Bulletin No:	B414R1225-0
Release Date:	October 25, 1999
Effective Date:	October 25, 1999
Supersedes:	N/A
Completion Date:	November 25, 1999
Page:	1 of 6

SERVICE BULLETIN

Ride Name:	INVERTER (Portable Model)	Affected Serial Nos.:	Prior to 414-02399
	INVERTER (Park Model)		Prior to 414-008P99
	DOUBLE INVERTER		Prior to 414-008P99

Abstract of Issue:
Vehicle Air System Rework

Installation Instructions - Vehicle Air System Rework

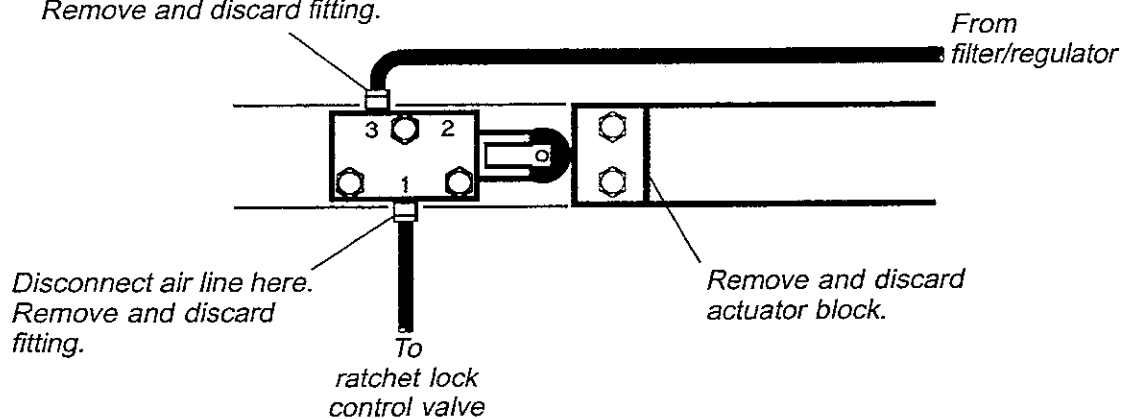
1. Turn off the power to the vehicle and drain the air system of all pressure.
2. Locate the step interlock valve, visible on the tower side of the vehicle through an access opening.
3. Disconnect the two air lines coming from the step interlock valve. To remove the air line, push the locking collar in toward the fitting, and pull straight out on the line.

Disconnect air line here.

Remove and discard fitting.

IMPORTANT: Do not disconnect both ends of these two lines; only disconnect them at the step interlock valve. Pay attention to where the lines are connected and how they are routed before disconnecting.

4. Remove the two fittings from the valve and discard them.
5. Remove the actuator block from the step lock slide bar. Set the fasteners aside for later use. Discard the old actuator block.

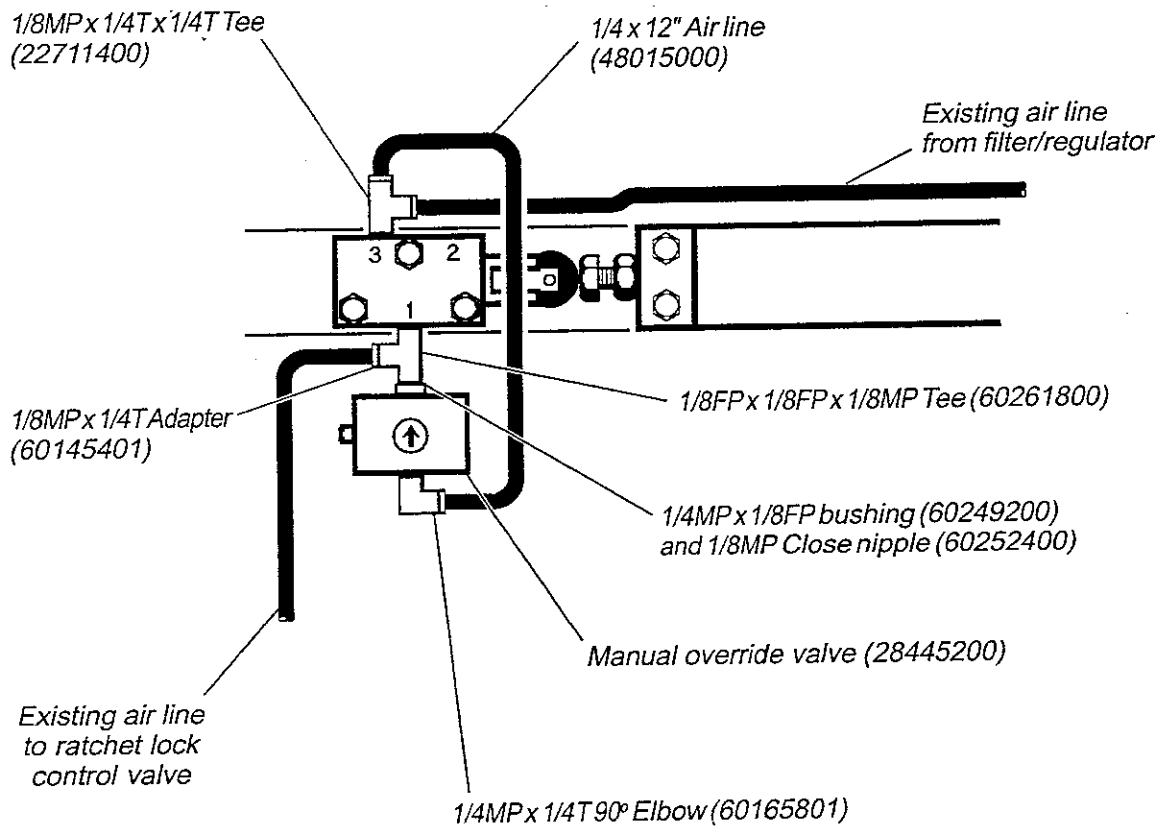
8. Install the air lines and fittings as shown below.
